PROPOSED STORAGE BUILDING FOR
BILL RAMOS
4608 McLEOD DR. N.E.
ALBUQUERQUE, NEW MEXICO

GRADING/DRAINAGE PLAN

Job Title
PROPOSED STORAGE BUILDING FOR
BILL RAMOS
4608 McLEOD DR. N.E.
ALBUQUERQUE, NEW MEXICO

GRADING & DRAINAGE PLAN

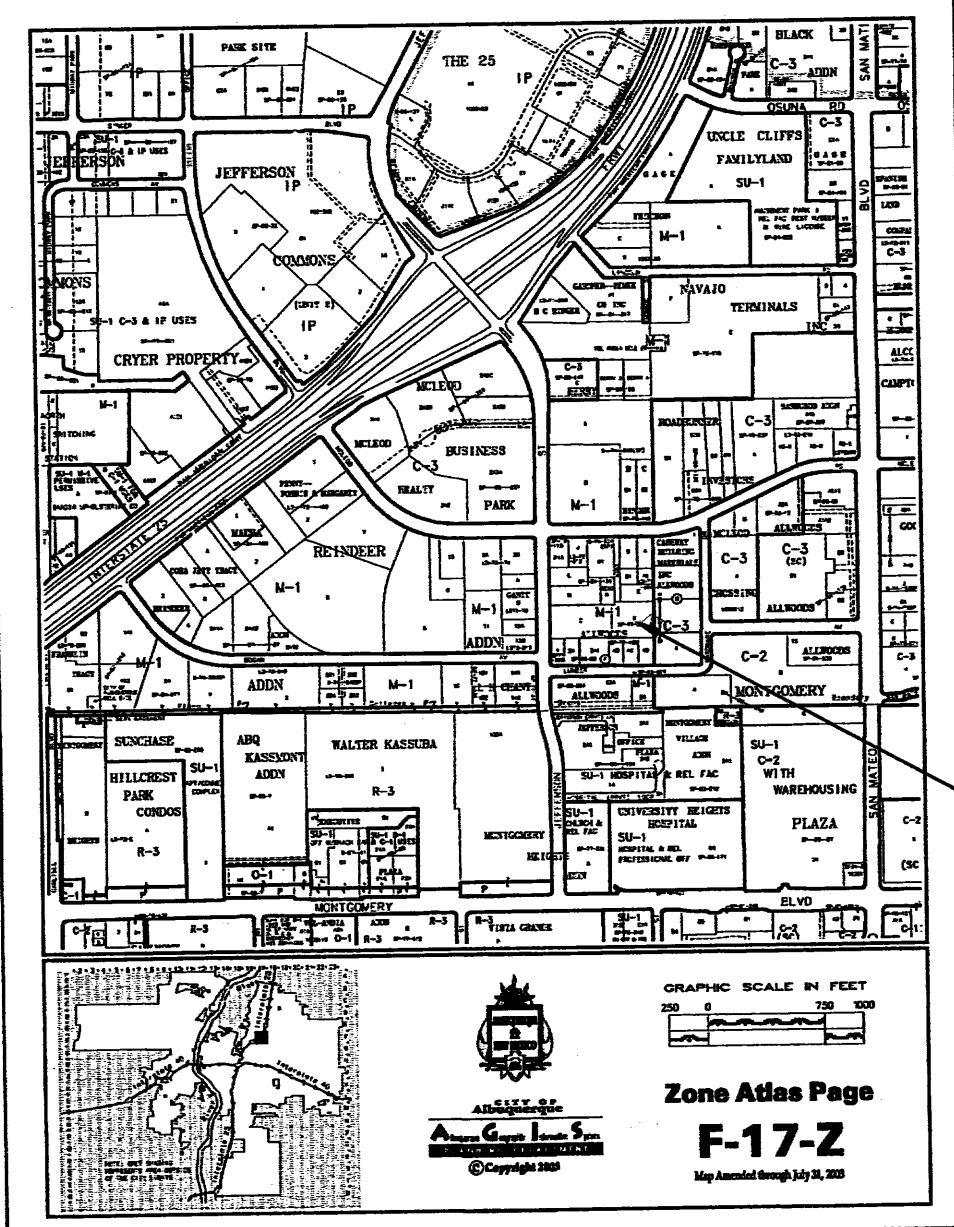
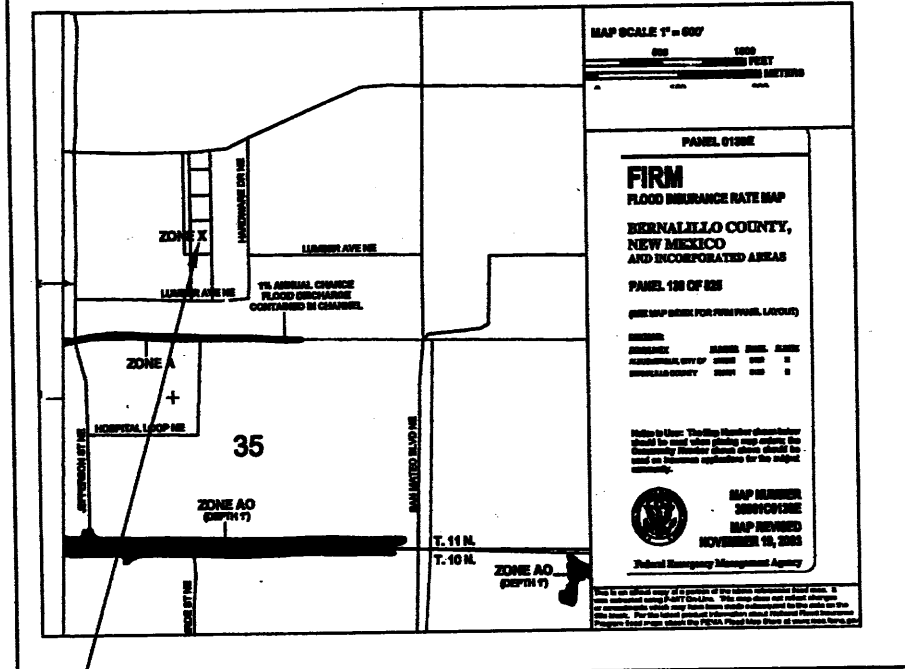
Too Small

The layout shown does not match what is shown in the 2004 Aerial - must show all existing pavement and buildings w/ elevations

Finished floor elevations do not match those provided in the approved plan (11/98)

PER ARIAL
